MEMORANDUM

PLANNING COMMISSION MEETING

Agenda Planning Commission

City of Decatur, AL

CERTIFICATE TO CONSOLIDATE NO. 3319-16

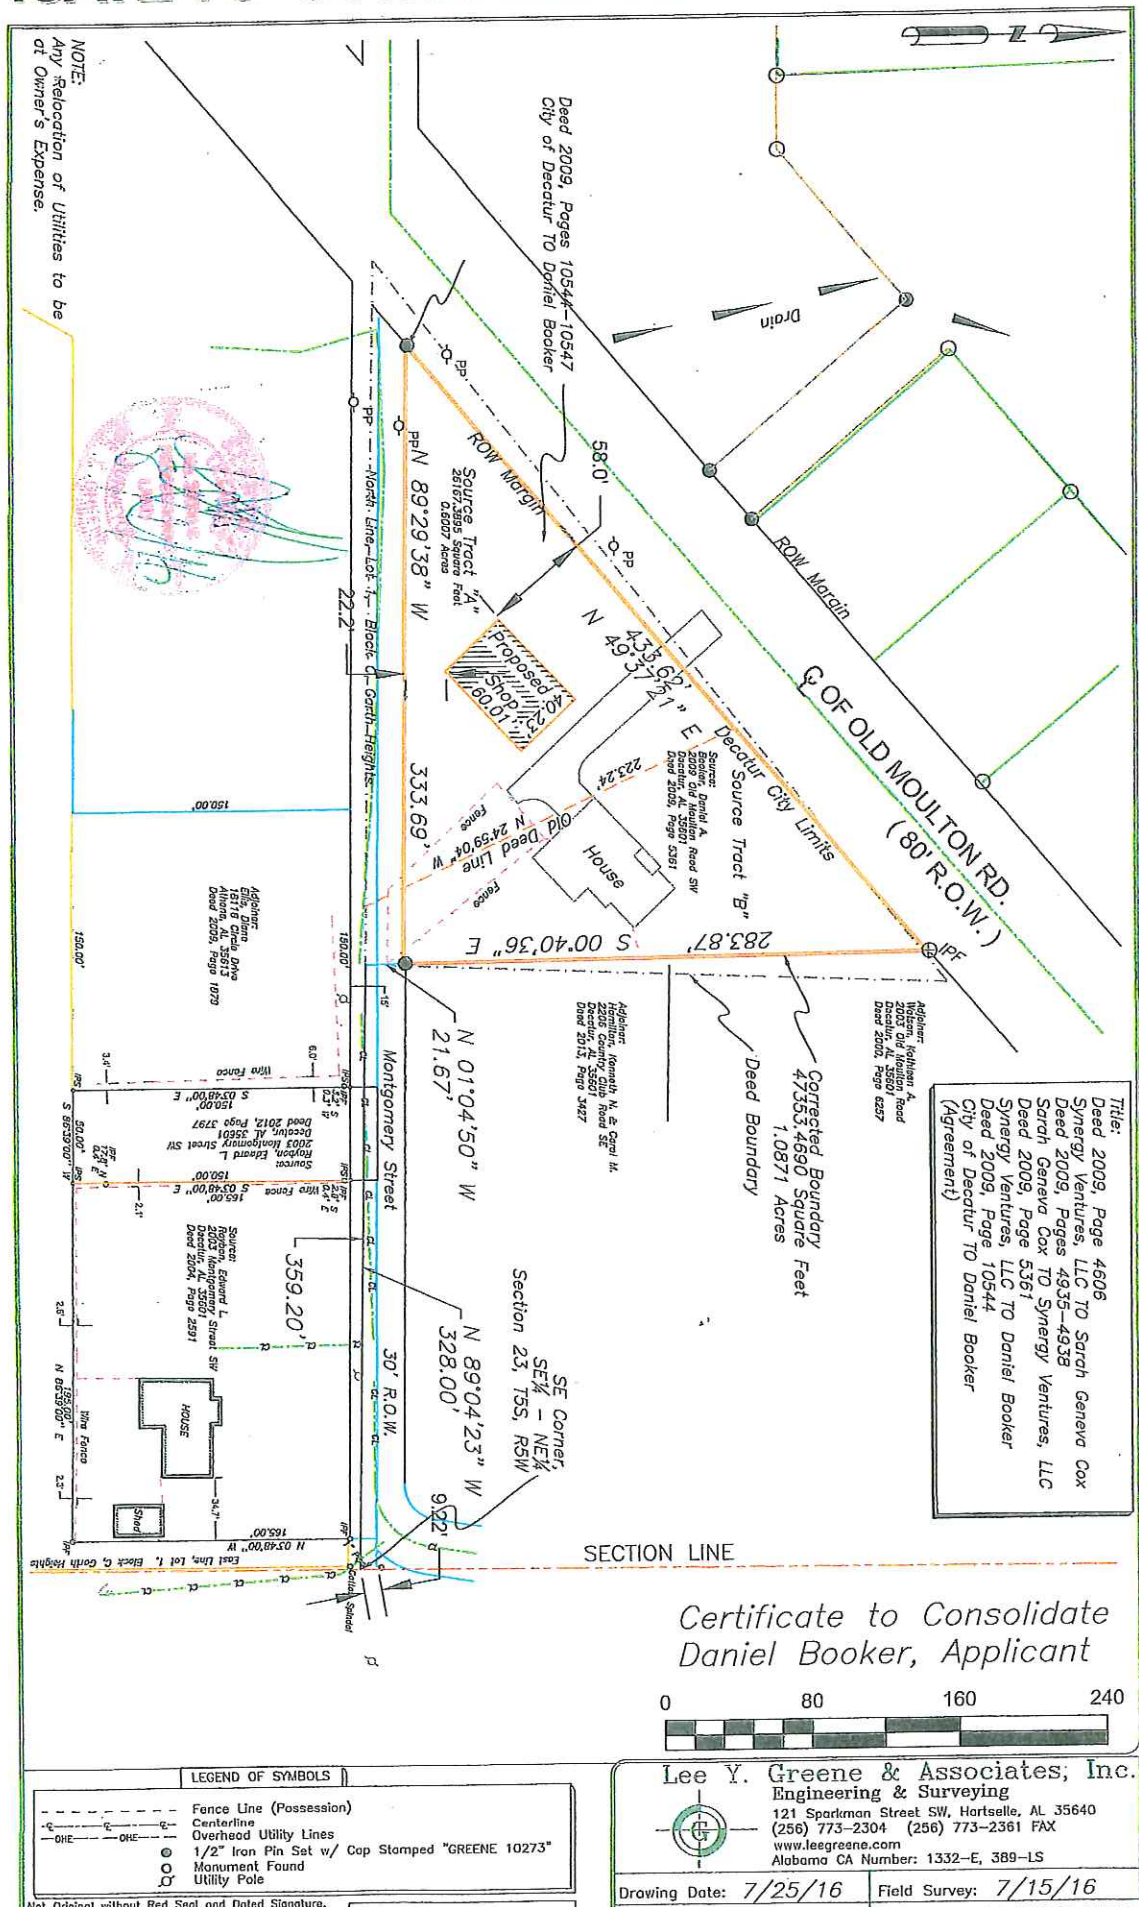
- Conds:
1. Provide copy of deed showing ownership of the property
 2. Payment of recording fees
 3. Provide signed letter from property owner requesting consolidation of property
 4. Amend survey to show four state plane coordinates based on NAD83 AL West Zone
 5. Verify/obtain septic tank approval
 6. Show/dedicate 10' (5' either side) easement for existing power line on the east property line

CERTIFICATE TO SUBDIVIDE AND CONSOLIDATE NO. 3320-16

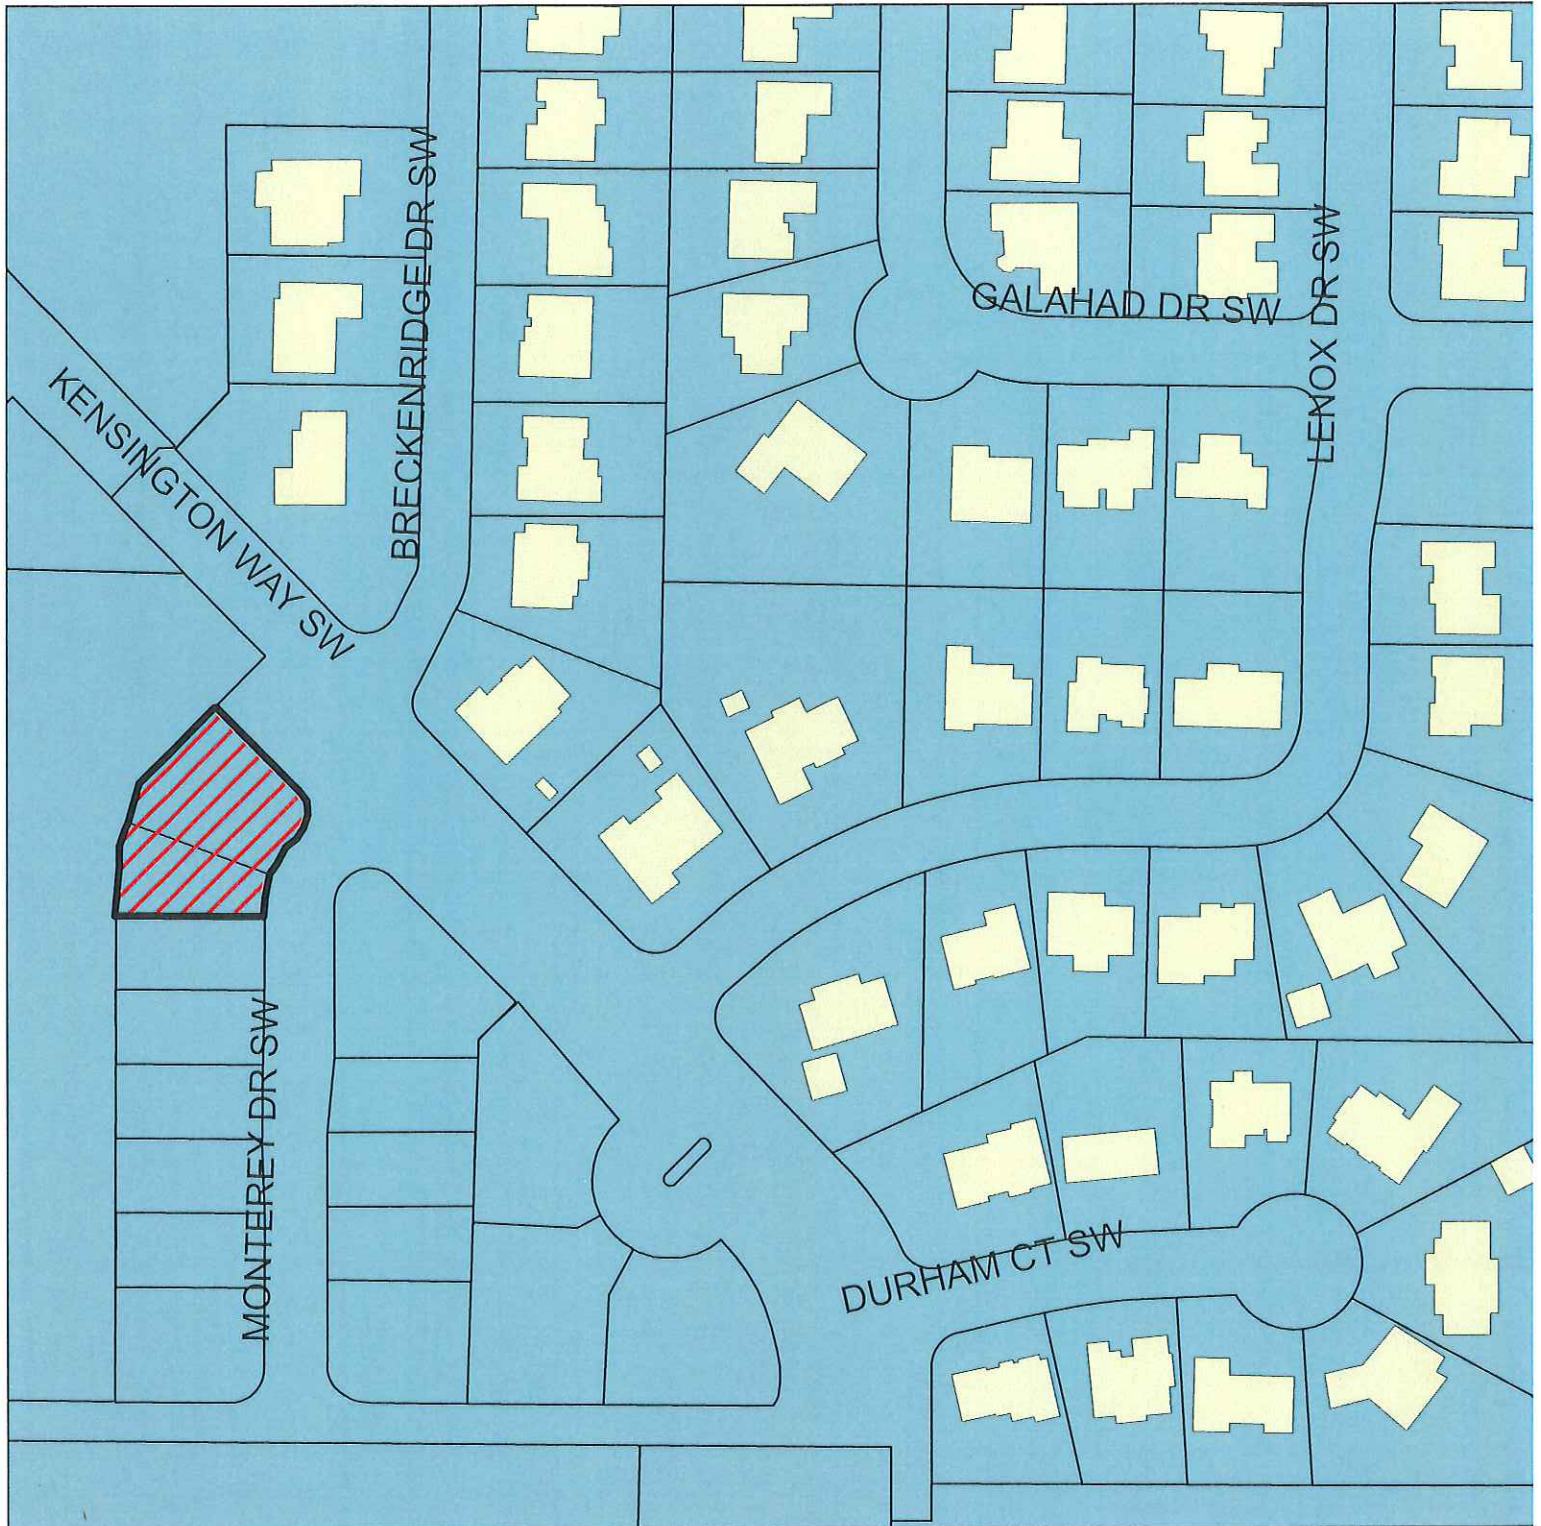
1. Provide signed letter from all property owners requesting subdivision and consolidation
2. Payment of recording fees
3. Amend survey to show Lot 3
4. Show/dedicate easement for existing electric line on the source tract C – per DU
5. Dedicate easement for existing gas line on Lot 3, Longleaf Estates, Add. #4 – per DU

CERTIFICATE TO CONSOLIDATE NO. 3321-16

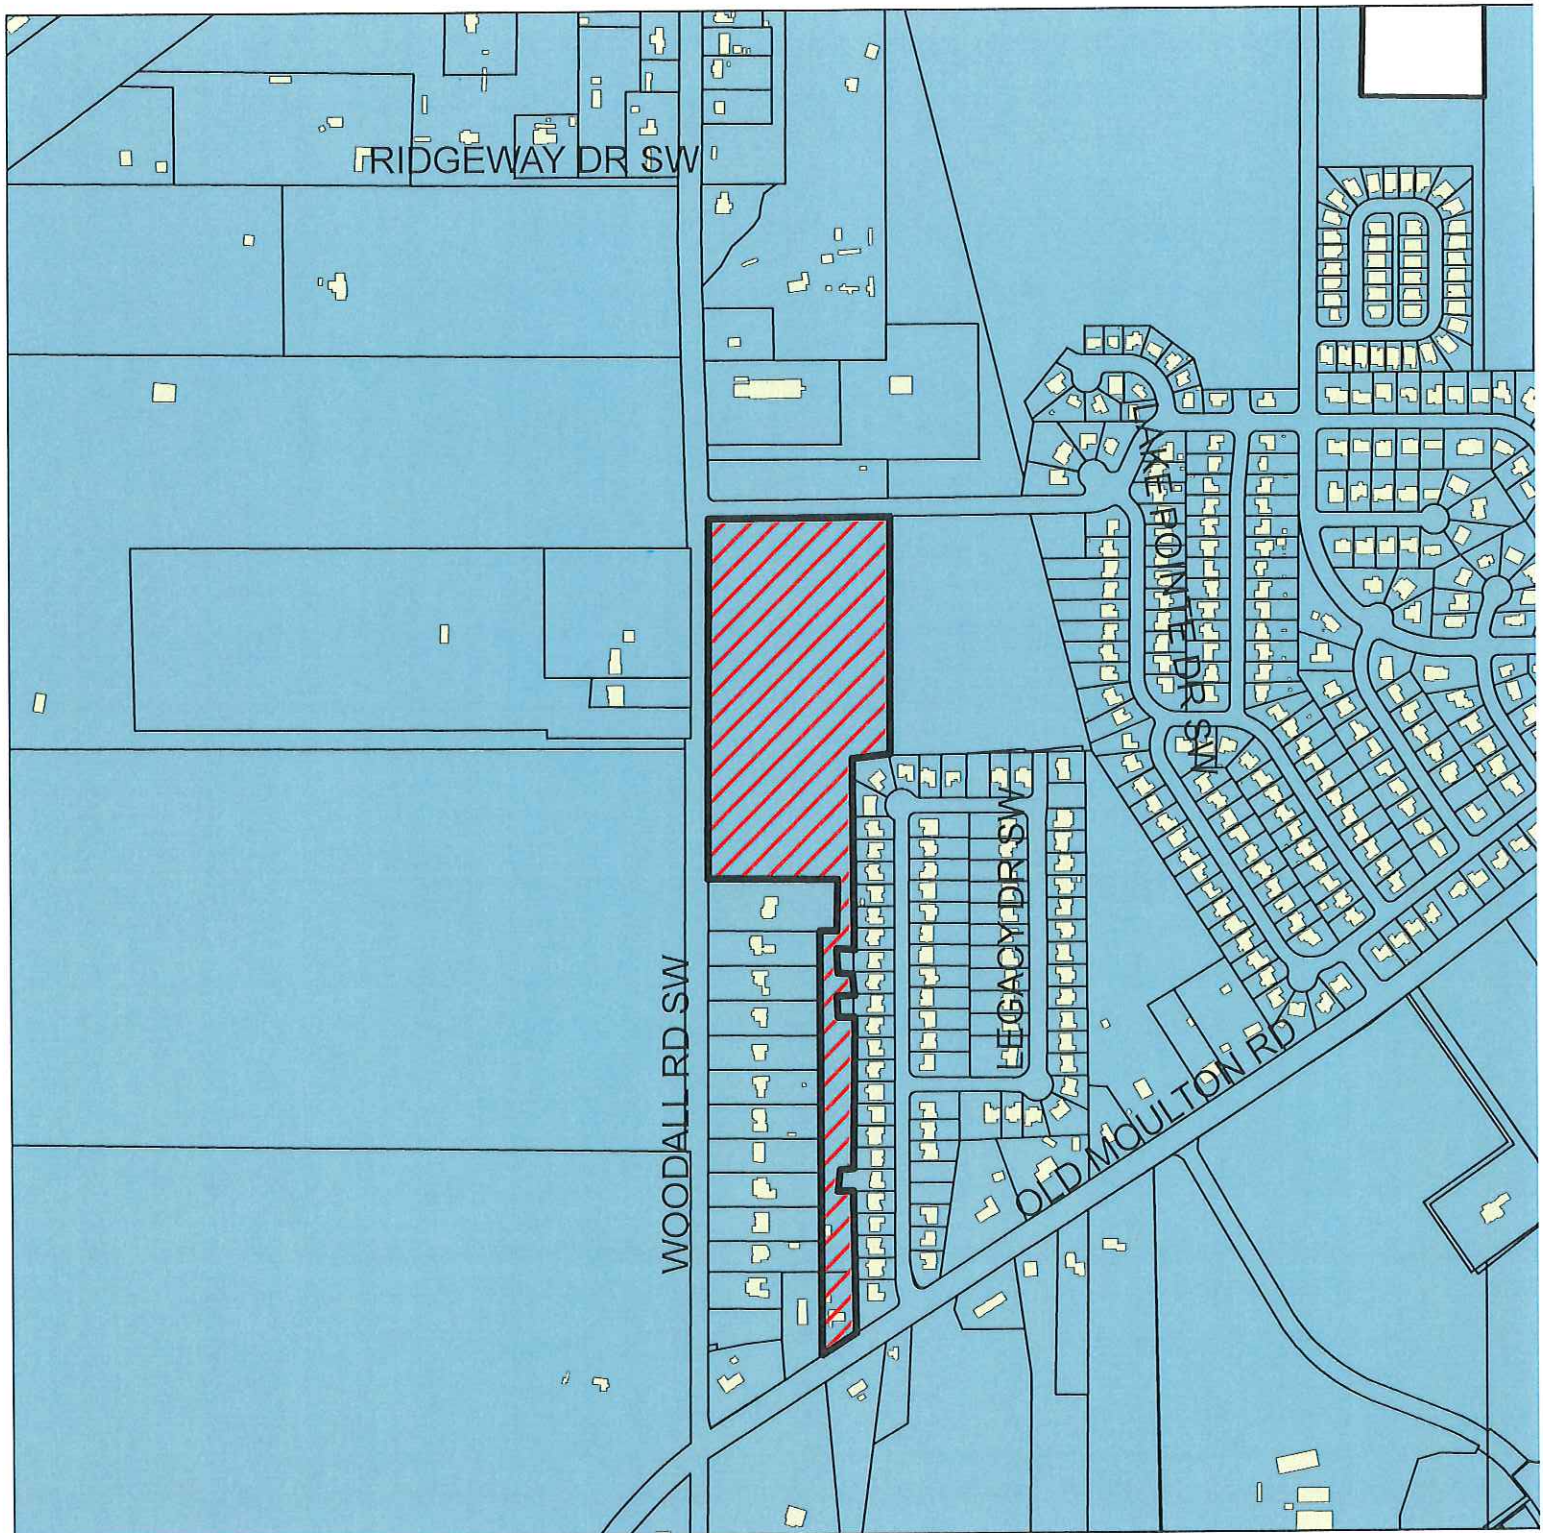
1. Payment of recording fees
2. Provide copy of deed showing property ownership
3. Provide a stamped and sealed survey for recording
4. Amend survey to show four state plane coordinates based on NAD83 AL West Zone

CERTIFICATE TO SUBDIVIDE AND CONSOLIDATE NO. 3322-16

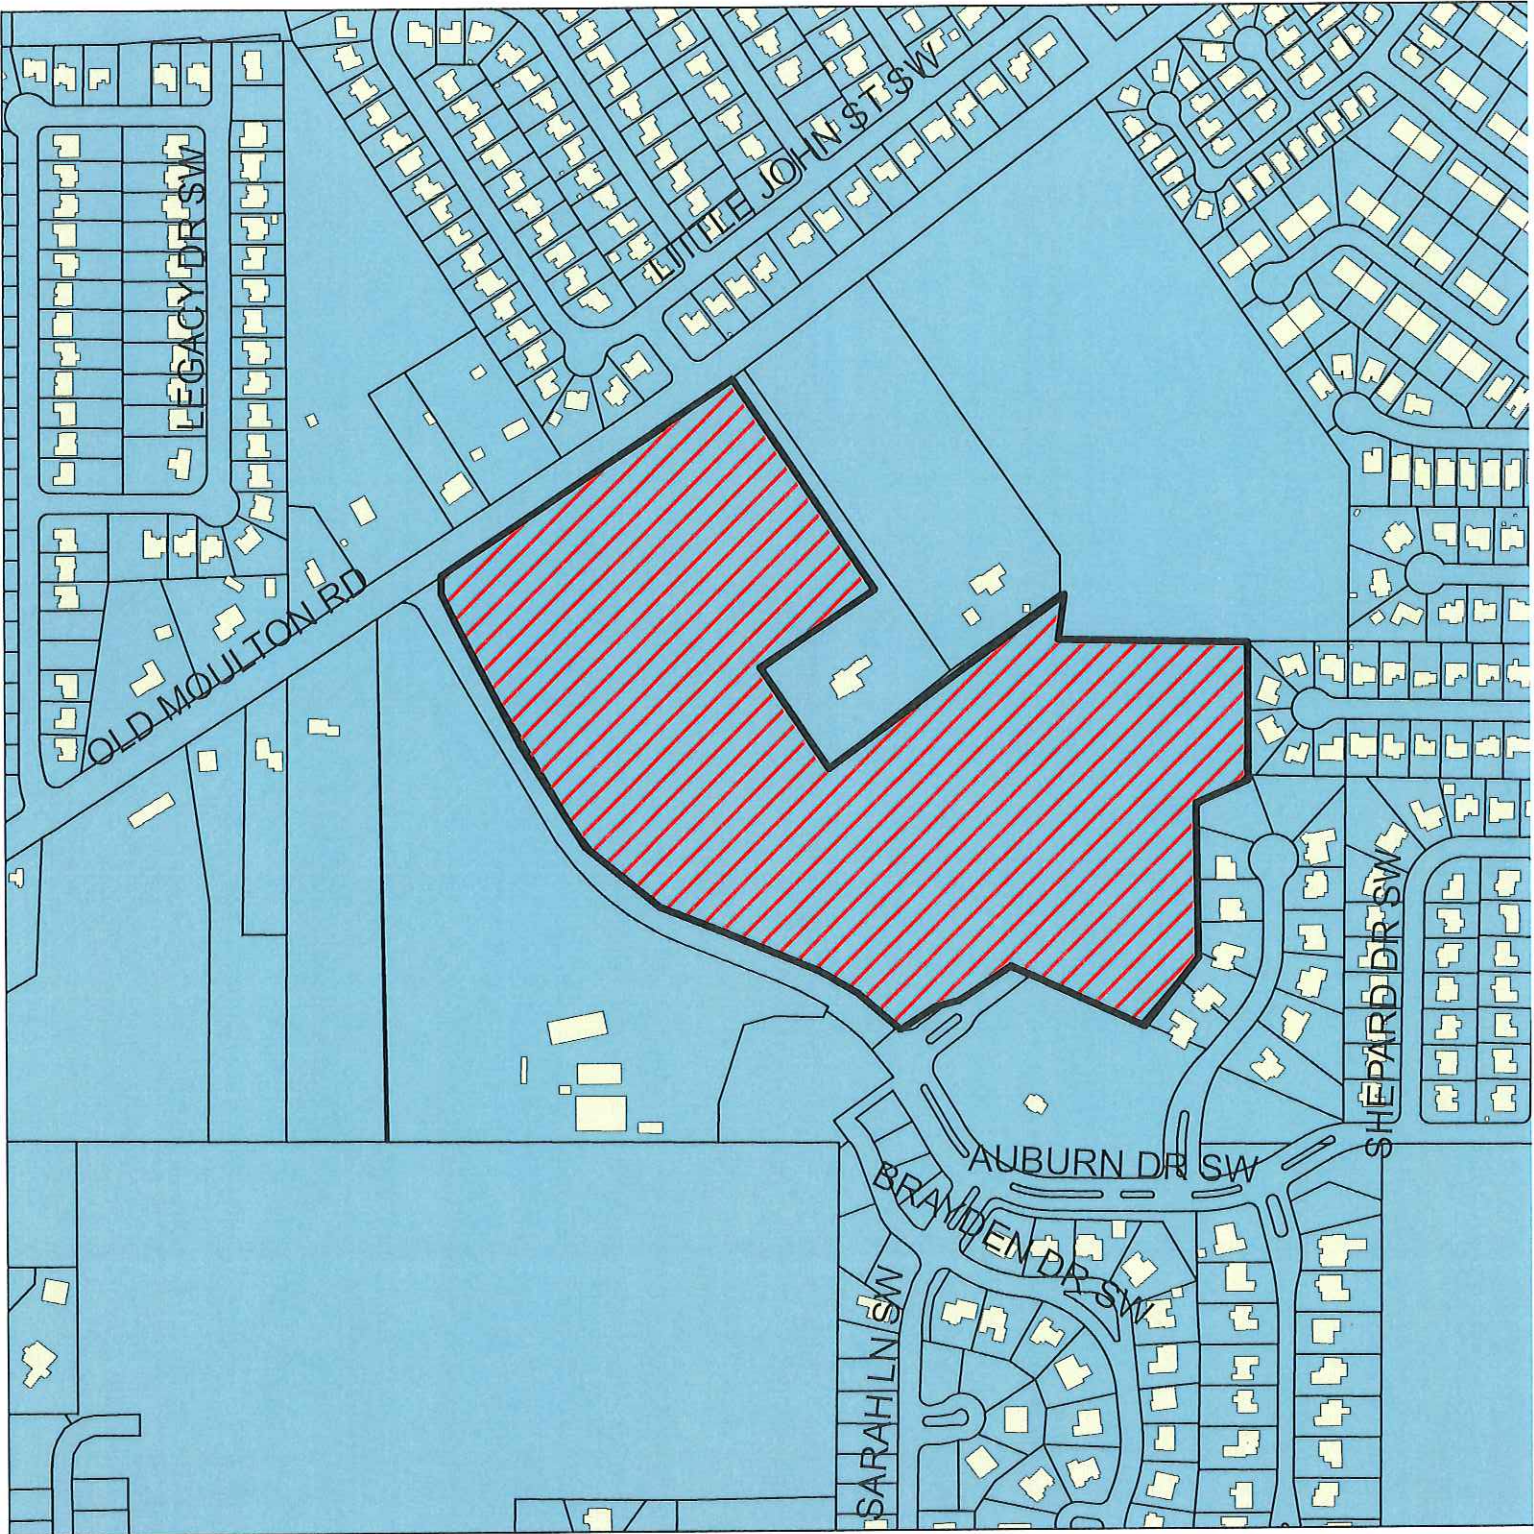
- Conds:
1. Payment of recording fees
 2. Amend survey to show four state plane coordinates based on NAD83 AL West Zone on the survey
 3. Verify/obtain septic tank approval for Unit 1
